PRODUCT CHANGE NOTIFICATION

Date: September 19, 2016
PCN: PCN LEDIL 126 a, b, c

Subject: PCN 126.c – Change in product mechanics

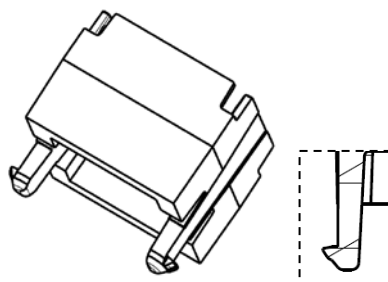
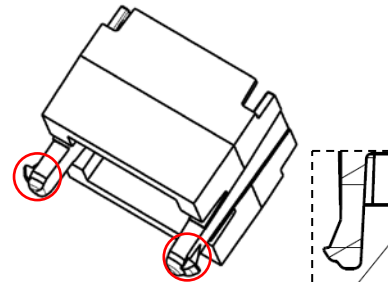
Description: As part of our continuous improvement process regarding the quality of our products, LEDiL is planning to change LARISA-CLIP design to improve fastening to the PCB.

Changes: Clip design has been made more robust to improve fastening on the PCB. The mechanical compatibility remains unchanged.
